Access Compliance Report

Public Rights-of-Way

(Curb Ramps)

Intersection ID: 26692	Main Street: MANOR_HOUSE_DR	Cross Street: MISTY_HILL_LN	Location: W
ADA ID: B23F3B8B35A1	Ramp Type: Perp	Initial Pass/Fail: Fail	Overall Compliance: No
Severity Score: 1.25			
Codes/Mitigation Info/Possible Solution		Field Measurements/Component Compliance

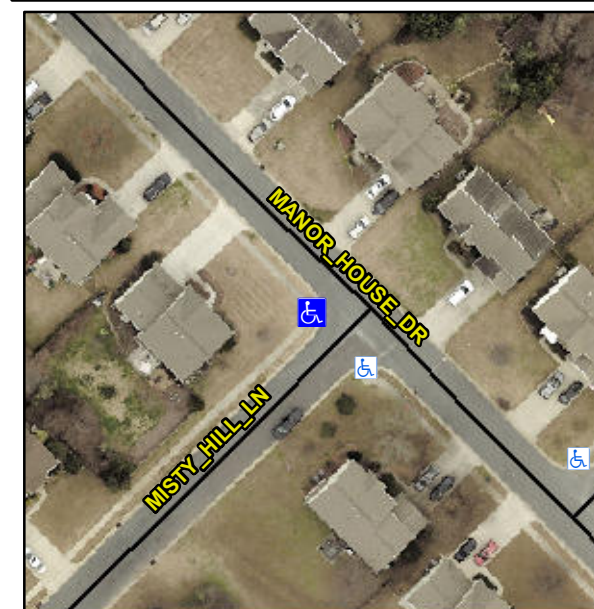
Not Found, R304.5.3

Compliance	Description	Data	Compliance	Description	Data
N/A	Ramp Length (in)	48.0	Yes	Ramp Slope (%)	5.0
Yes	Ramp Width (in)	48.0	No	Ramp XSlope (%)	2.8
N/A	Flare Type LT	N/A	N/A	Flare Type RT	N/A
N/A	Flare Slope LT (%)	N/A	N/A	Flare Slope RT (%)	N/A
N/A	Flare Traversable LT?	N/A	N/A	Flare Traversable RT?	N/A
N/A	Landing Length (in)	N/A	N/A	DWS Provided?	N/A
N/A	Landing Width (in)	N/A	N/A	DWS Contrast?	N/A
N/A	Landing Slope (%)	N/A	N/A	DWS Length (in)	N/A
N/A	Landing X Slope (%)	N/A	N/A	DWS Full Width?	N/A
N/A	Landing Curb? (Y/N)	N/A	N/A	DWS Offset (in)	N/A
N/A	Shared Landing?	N/A			
N/A	Gutter Ponding?	N/A	N/A	Gutter Slope (%)	N/A
N/A	Gutter Lip Ht (in)	N/A	N/A	Gutter X Slope (%)	N/A
N/A	Painted X Walk1?	No	N/A	Painted X Walk2?	N/A
	X Walk 1 Direction	To SW		X Walk 2 Direction	N/A
N/A	X Walk 1 Width (in)	N/A	N/A	X Walk 2 Width (in)	N/A
	X Walk 1 Slope (%)	4.1		X Walk 2 Slope (%)	N/A
	X Walk 1 X Slope (%)	4.2		X Walk 2 X Slope (%)	N/A

Remove & Replace Entire Ramp.
